ART AEROSPACE LTD	Work Order:	23263
Description: Driveshaft Tunnel Modification Kit	Part Number:	D412-705-015
Dwg: D3256 Rev. A	Qty:	12 Kit(s)

DESIGN RF	DRAWN BY RF	DART AEROSPACE LTD HAWKESBURY, ONTARIO, CANADA	
CHECKED	APPROVED	DRAWING NO. D3256	REV. B SHEET 1 OF 3
DATE 05.06.27		TITLE ACCESS PANEL ASSEMBLY	SCALE 1:6
A	04.01.27	NEW ISSUE	
B	05.06.27	D3256-3 DIM 1.30 WAS 0.65

D3256-041 ACCESS PANEL ASSEMBLY

D3256-3 GASKET

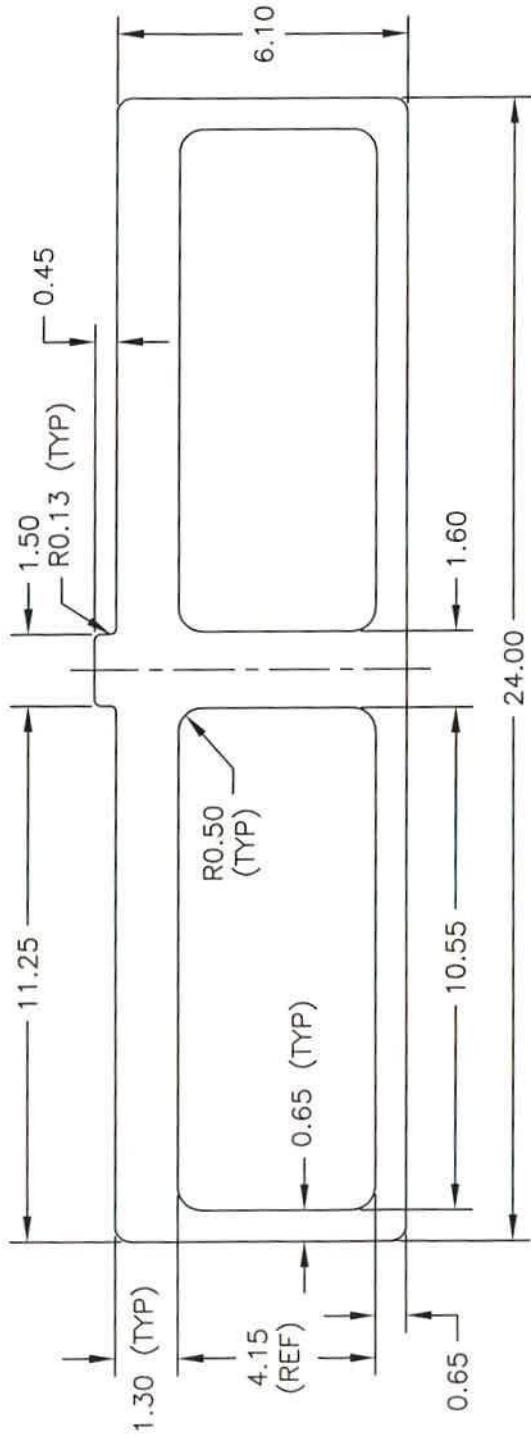
>> better. They will still be getting a D3256-041, but with a different
>> gasket.

>> The shape of the gasket has been changed to fit better. Don't cancel the
>> PO,
